YANG for IEC/IEEE 60802 Constrained Devices

Author:
Martin Mittelberger, Siemens AG

12/2024

Proposal for integration of YANG for constrained devices

1.1 Module iecieeee60802-proxy

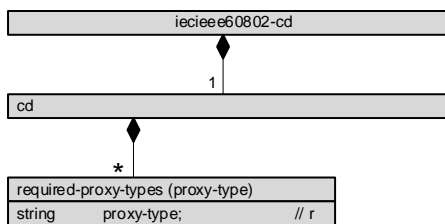
1 Add the following UML-like diagram to clause 6.4.10.5:
